Interactive comment on “A cross-scale study for compound flooding processes during Hurricane Florence” by Fei Ye et al.

Received and published: 17 January 2021

Fig. 1.

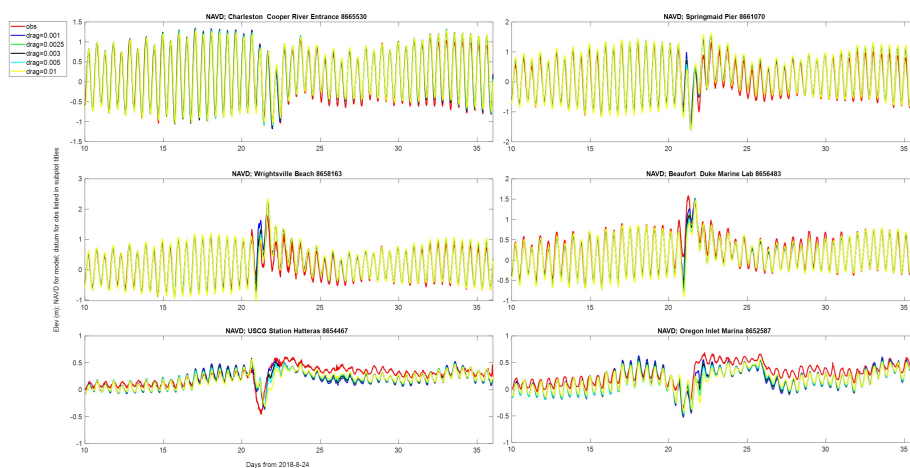
We agree with the reviewer that “The tuning of friction values is intentionally kept to minimum in favour of simplicity” is not a good statement. We will add more details on calibration in the revised version.

Calibration was indeed an important step during our model setup. The friction of the baseline model was tuned in wet area (river, estuary, ocean; lower than 1 m above MSL) and on higher grounds (higher than 3 m above MSL) separately. In the wet area, drag coefficients were tested within a range of 0.001-0.01. Commonly accepted default value of 0.0025 gave good error statistics near the landfall site; but as you can see from the attached figure, there is not a lot of sensitivity in the range of 0.001-0.005.
